**Earth Investigations Consultants**

July 1, 2004
Job 1663.01.01

RE: GEOTECHNICAL PEER REVIEW
Geotechnical and Hydrology Reports
Proposed Forest Green Estates, Tract 8268
Richmond, California

Plate 3	GEOLOGIC CROSS SECTION A-A Forrest Green, San Francisco Richmond, California	Job No. 100310101 Approved Date 6/2/04	Earth Investigations Consultants
------------	--	--	-------------------------------------

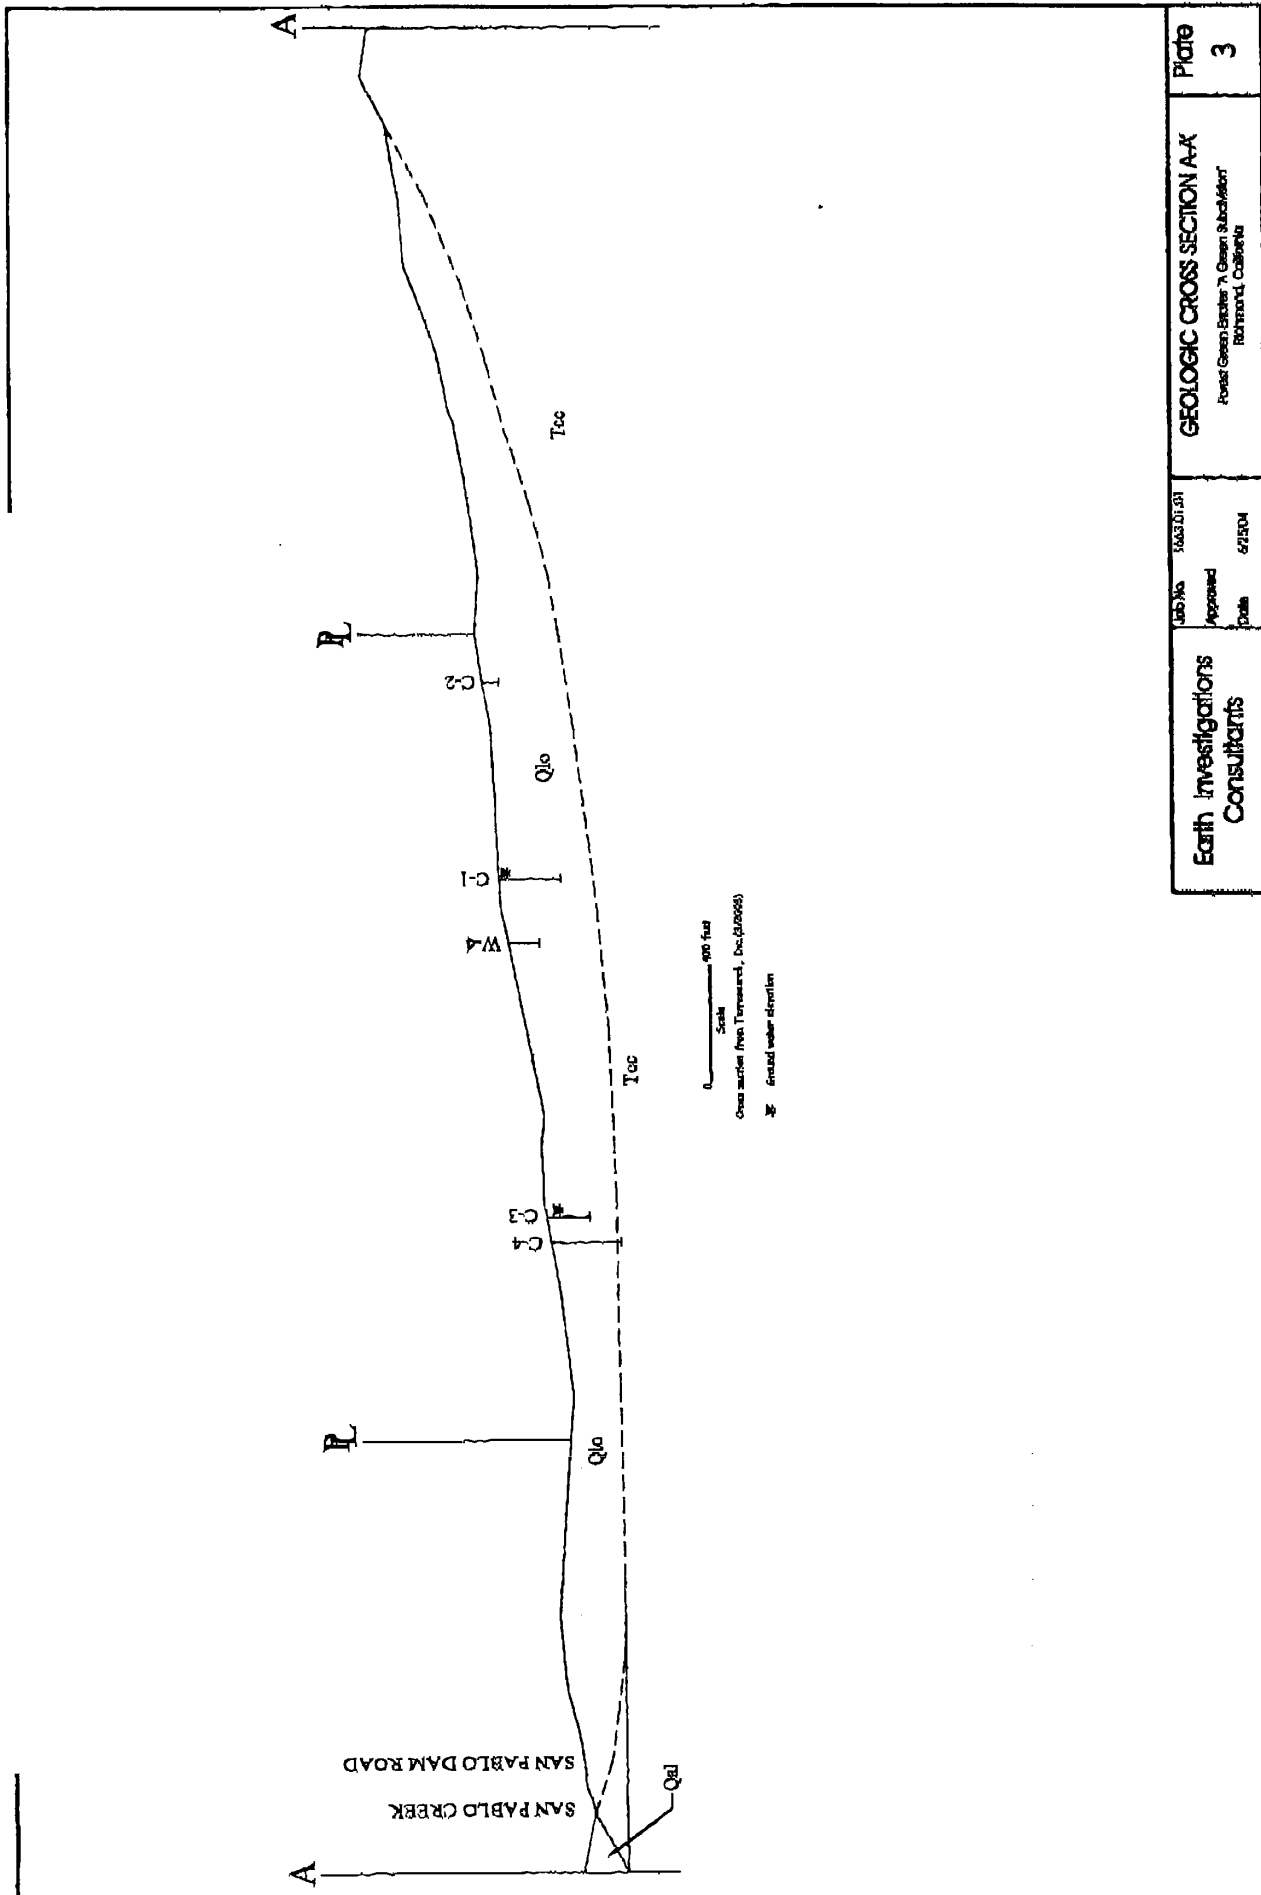
The geotechnical report prepared for the proposed project contains important geologic information pertaining to the relative distribution of landslides, and the quality of the earth material underling the site, but is deficient in presenting an understanding of the site ground water regime, mechanism and mode of landsliding, mode of failure, and future risks associated with the proposed project construction/mitigation. It is known that deep landsliding and creep are affecting areas to the west of the site where it has been established that ground water is the principal mechanism for complex translational/rotational failure in a deeper, creeping landslide. Stability analyses for this project do not account for potential creep, and are predicated on assumed ground water conditions. The site lies in a drainage basin that is likely to have perhaps substantial fluctuations in ground water elevation over a year of average rainfall. The stability analyses indicate that global instability to a depth of approximately 300 feet would occur if ground water were to rise within 100 feet of the surface; and that landslides to 150 feet deep could occur if ground water were to rise within 30 feet. This is significant because the proposed hydrologic mitigations recommend recharging the ground water regime to depths of 100 feet. Further, percolation from new seasonal wetlands and water quality basins could exacerbate local stability. Consequently, before project feasibility can be confirmed, it will be necessary to establish through careful monitoring of piezometers and wells, the pre- and post-construction ground water regime. Piezometers readings should be taken regularly over a minimum period of 1 year of average annual rainfall to establish the existing ground water elevation(s) for use in stability analyses. Ground water monitoring wells should be used to establish the impact of recharge to the existing ground water regime by the proposed hydrologic mitigations. Given the site is underlain by thoroughly sheared landslide debris that is expected to receive violent ground shaking during one or more major earthquakes over the project lifetime, conservative psuedo-static slope stability should be evaluated for a minimum factor of safety 1.1, as recommended in California Division of Mines and Geologic, *Special Report 117*.

Another imperative is that depth of creep be evaluated across the site by regular readings of individual slope indicator casing installed in borings at least 200 feet deep, over a period of at least 1 year of average annual rainfall. This measure is intended to empirically establish creep/landslide rupture distribution and depths. Creep monitoring should extend to a minimum depth of 200 feet at points throughout the site. Geologic information gained from this task will be extremely useful in,

The tentative map application for Subdivision #8268 should be denied until detailed ground water and landslide creep investigations confirm the proposed project will remain stable over the projected lifetime given existing geologic conditions and proposed geotechnical and hydrologic mitigations.
